### LEGAL NOTICE EXETER PLANNING BOARD AGENDA

Continued public hearing on the application of RiverWoods Company at Exeter for site plan review and Wetland CUP application for the demolition of the existing administrative building and the proposed construction of the new supportive living health center along with associated site improvement on the property located at 5 White Oak Drive. The subject property is located in the R-1, Low Density Residential zoning district and are identified as Tax Map Parcel #97-23. PB Case #24-16.

The application of StoneArch Development for site plan review of a proposal for the redevelopment of the property located at 112 Front Street. The proposal includes the demolition of the existing buildings and new construction of seventeen (17) townhouse style condominium units and associated site improvements. The subject property is located in the C-1, Central Area Commercial zoning district and identified as Tax Map Parcel #73-14. PB Case #24-17.

Re: 112 Front Street, LLC – 112 Front Street – Residential Development Response to UEI Comments

NHDES WATER CONNECTION

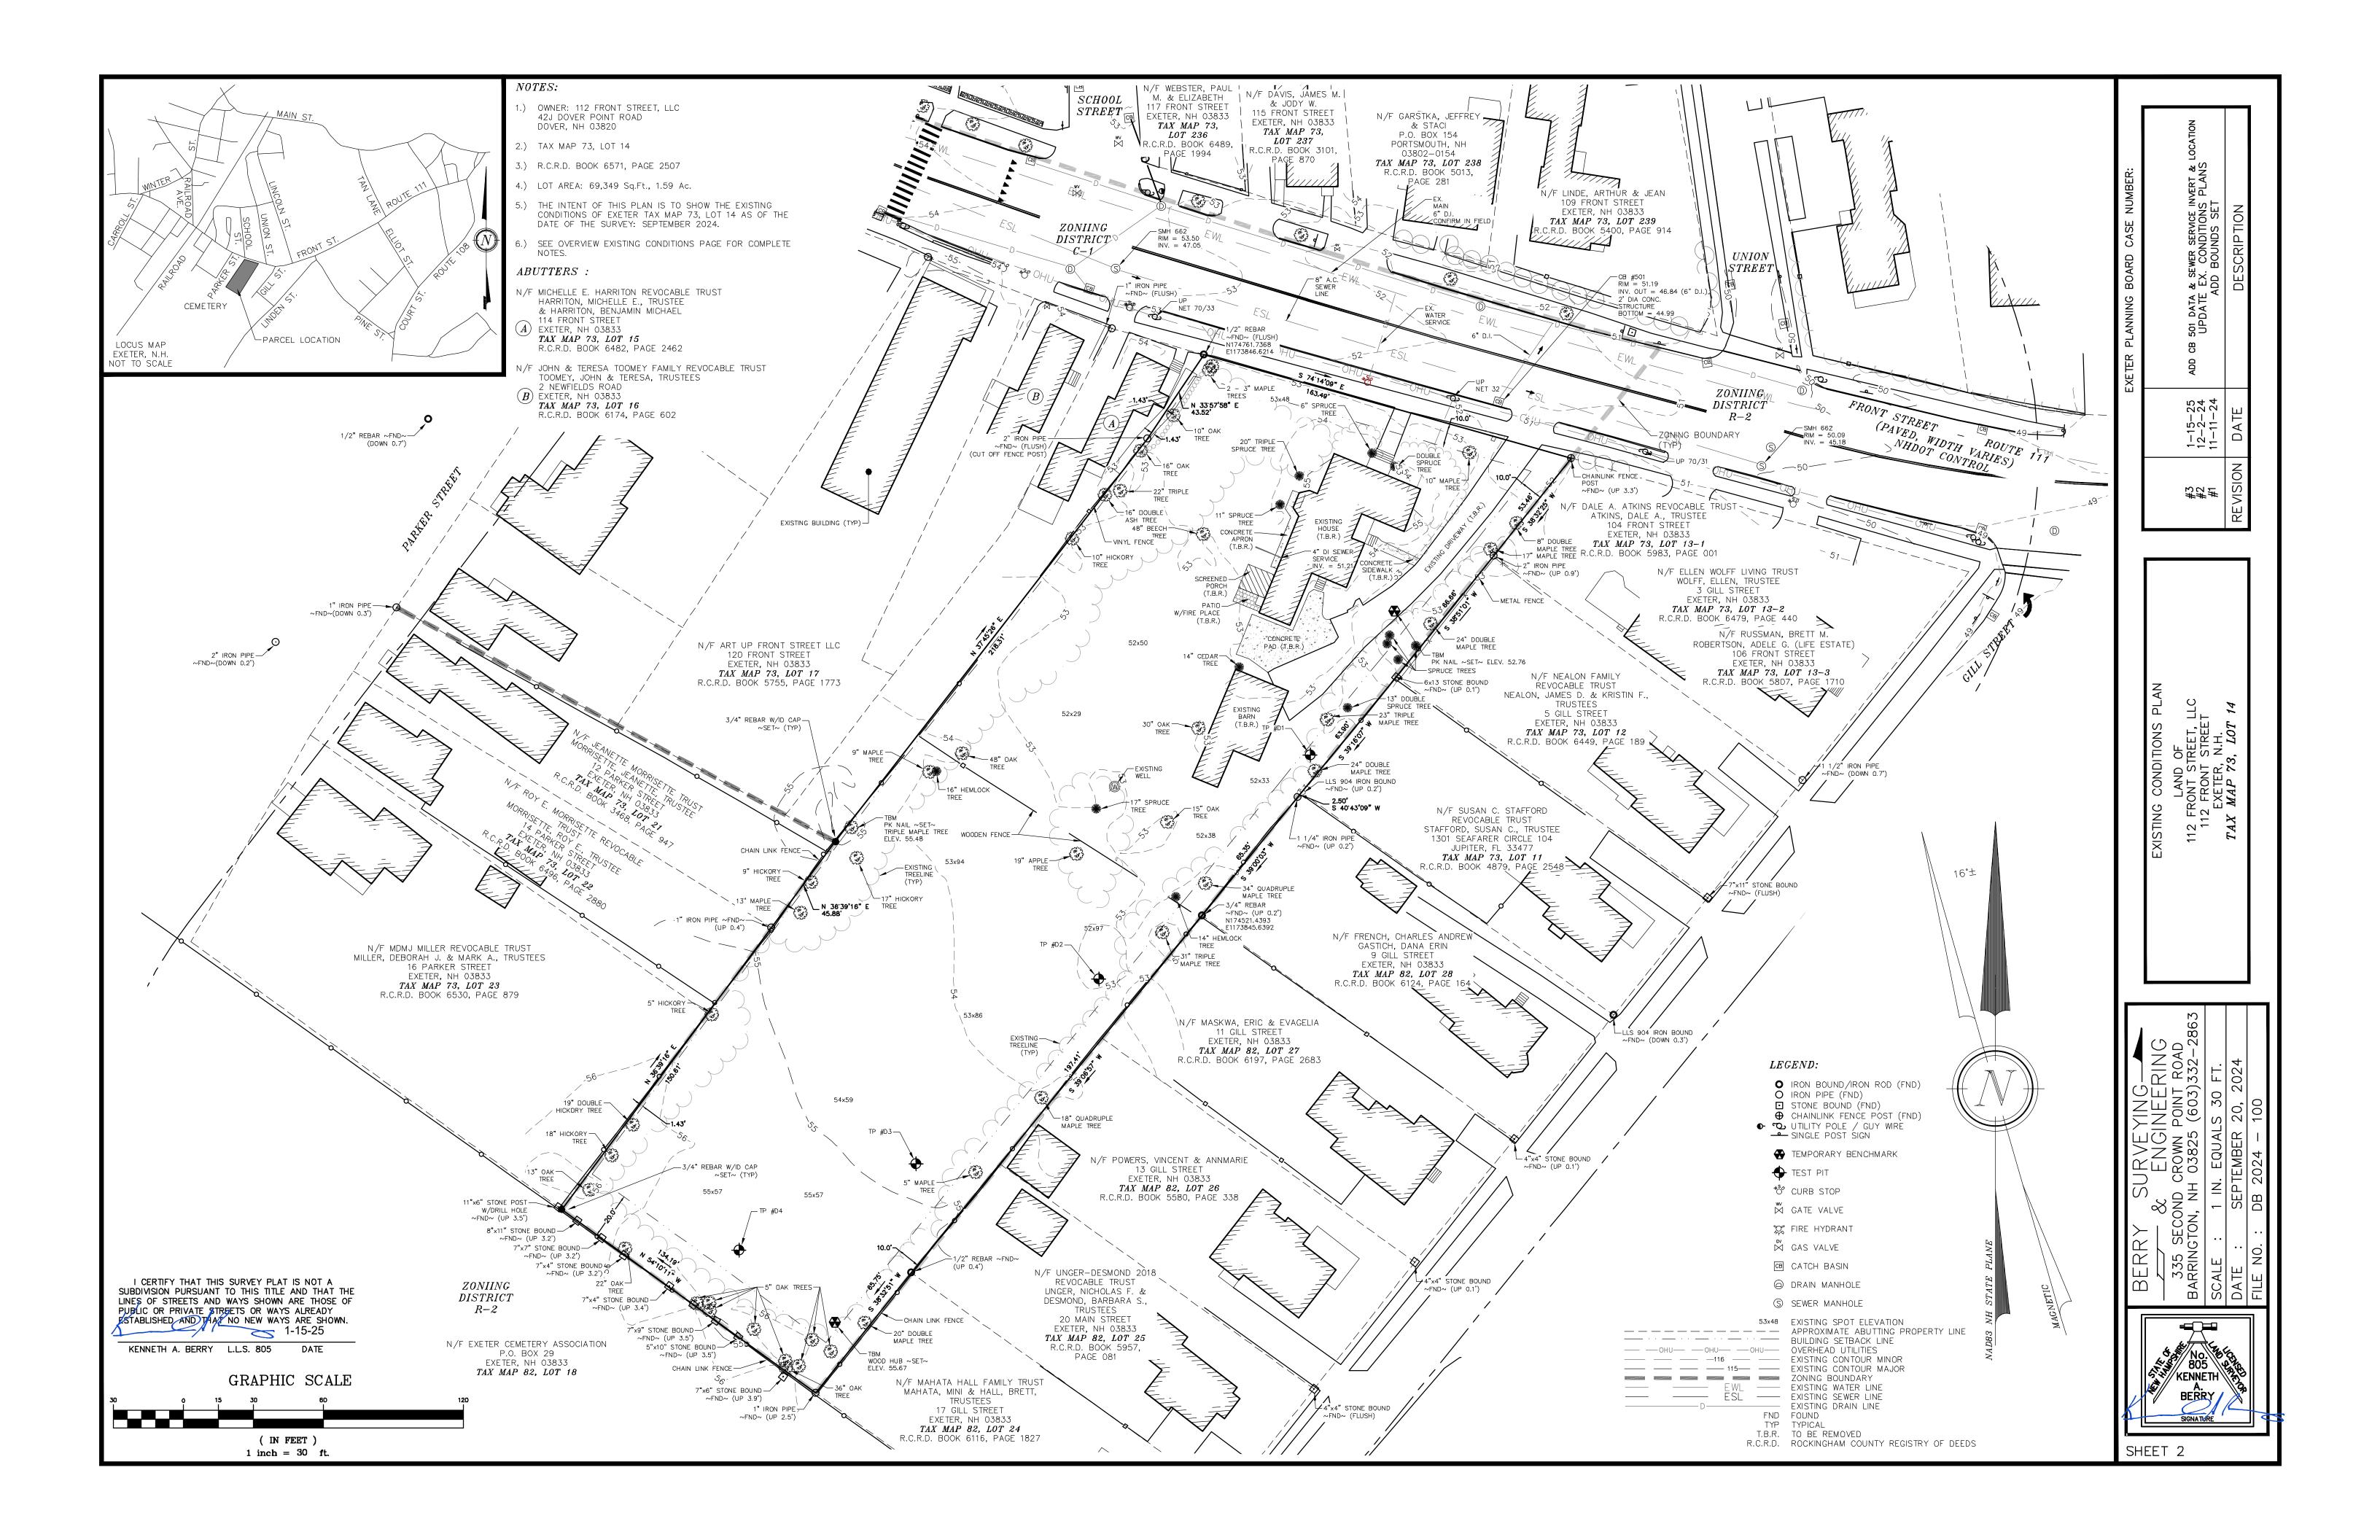
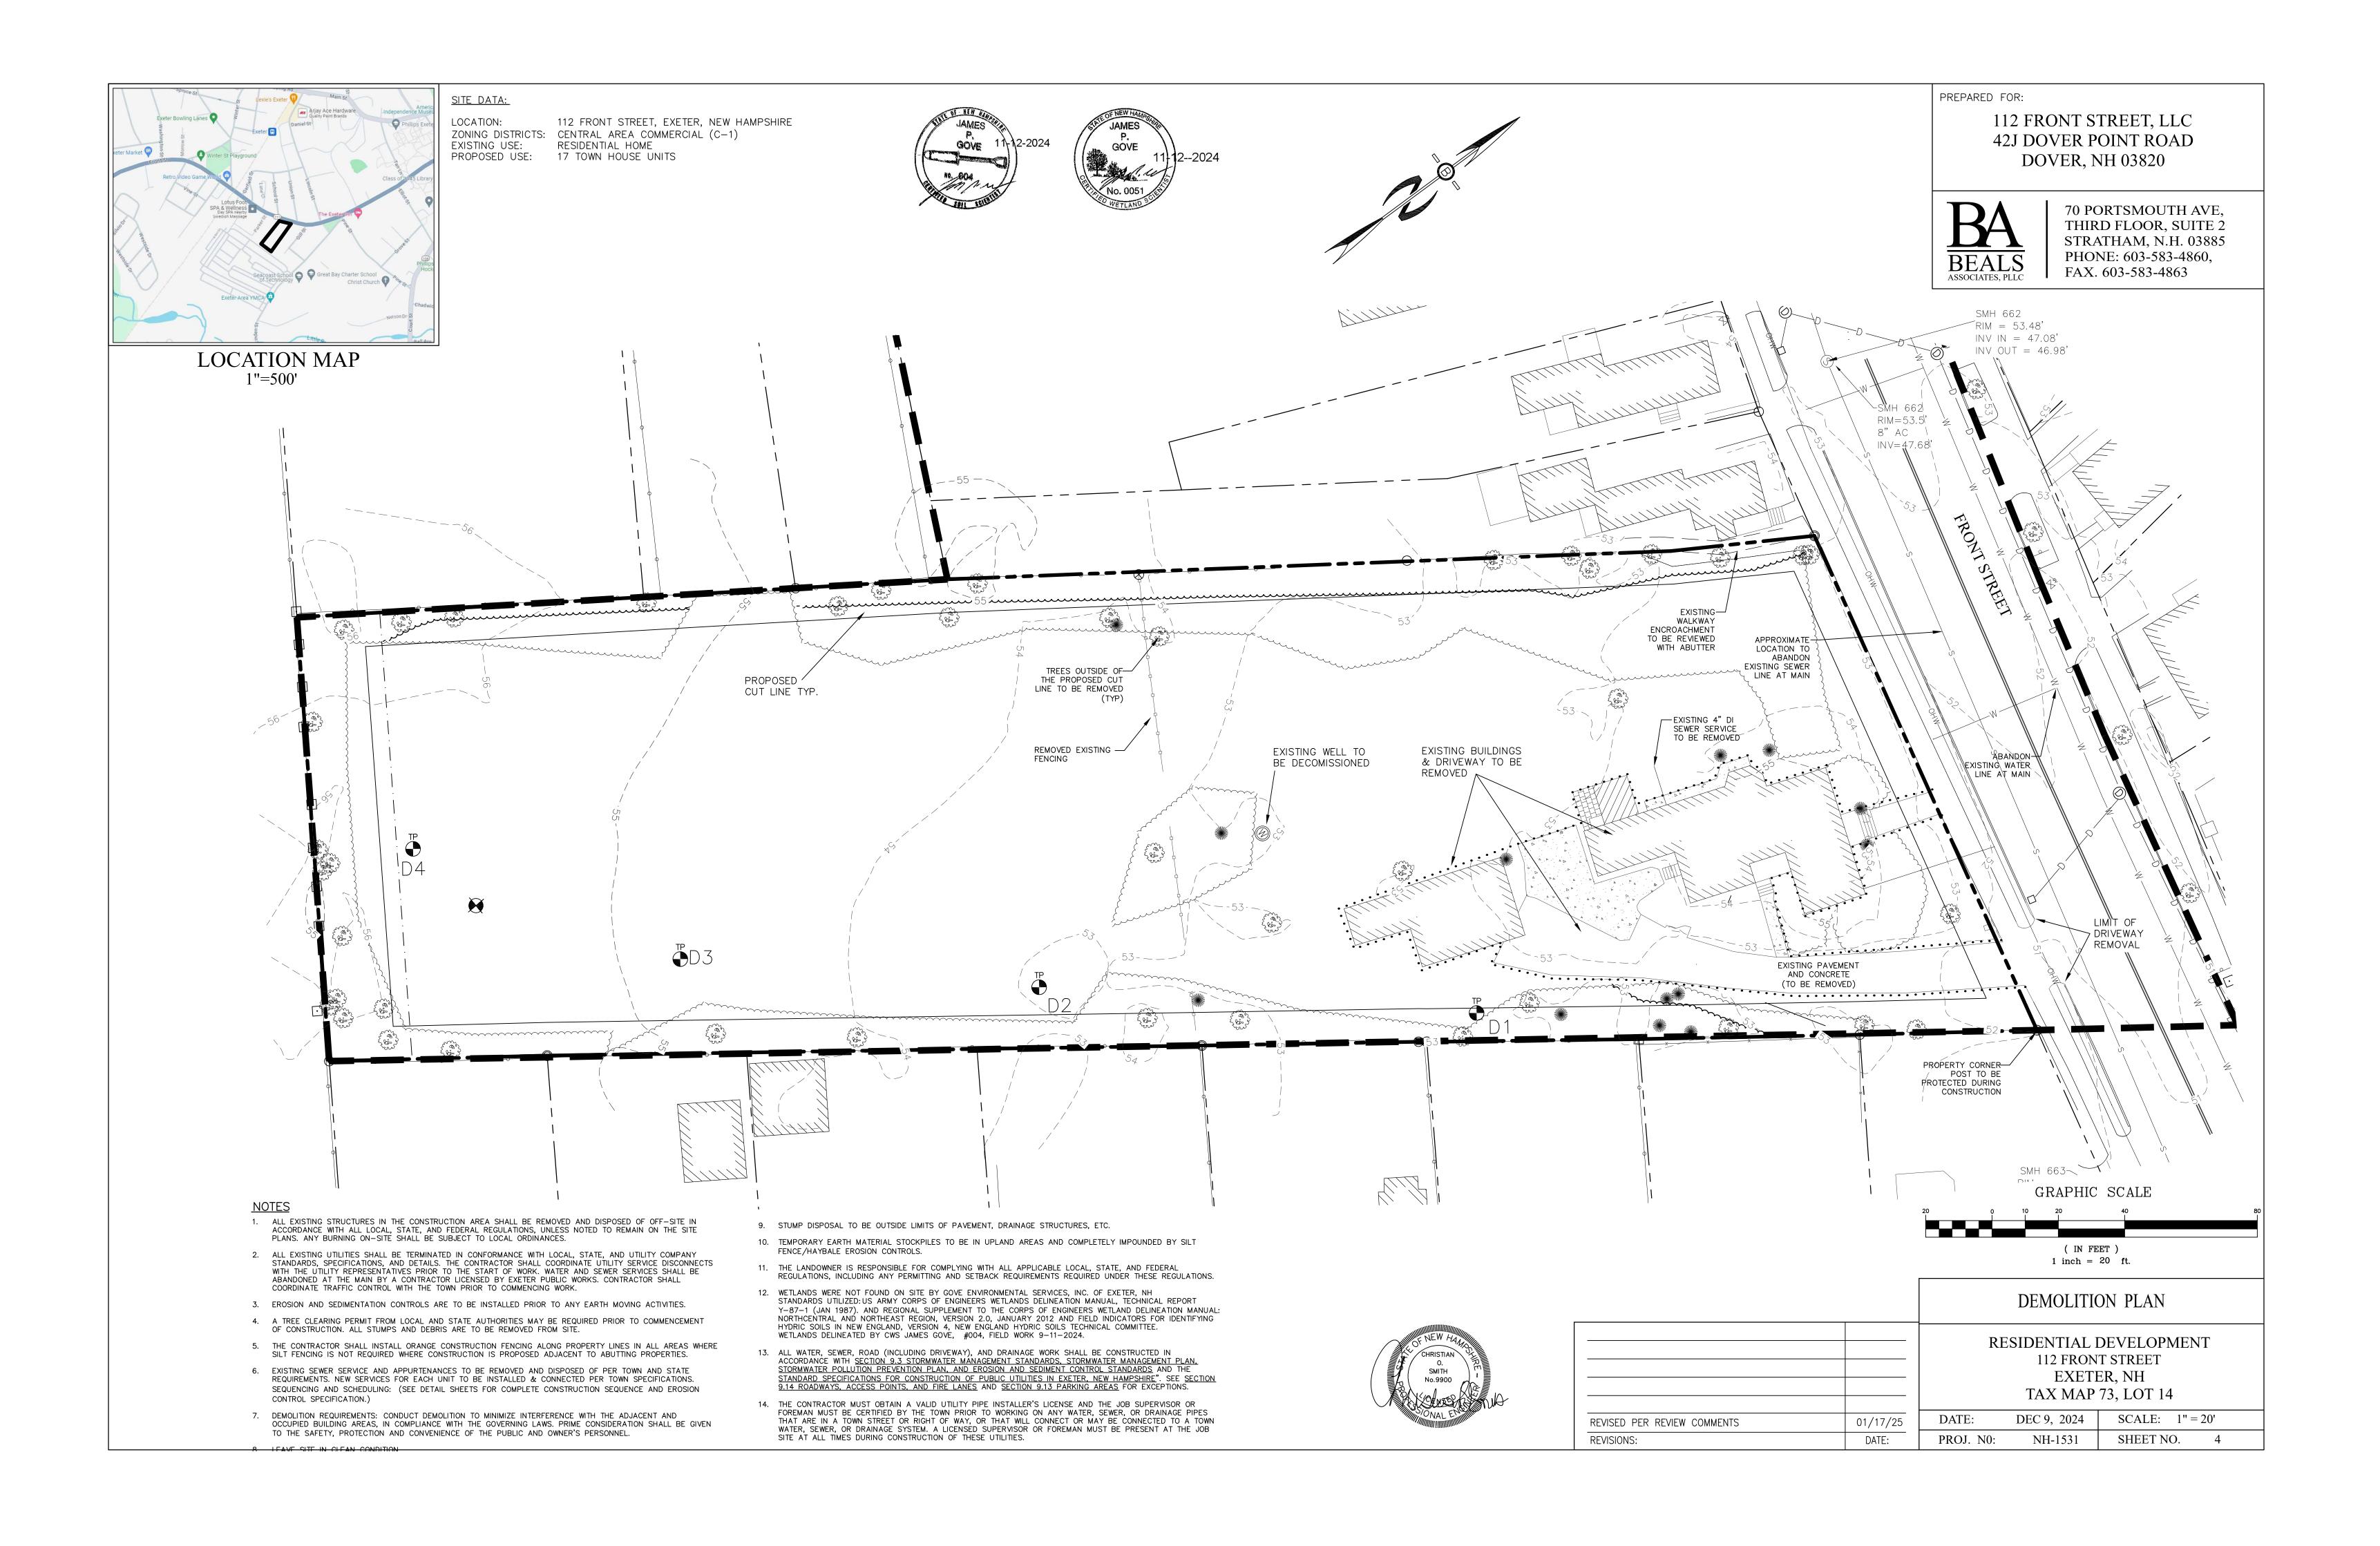
5. Per the comment above, if the encroachment will be removed, please label on plan.

Response: A label has been added to the Demolition Plan to call out the encroachment.
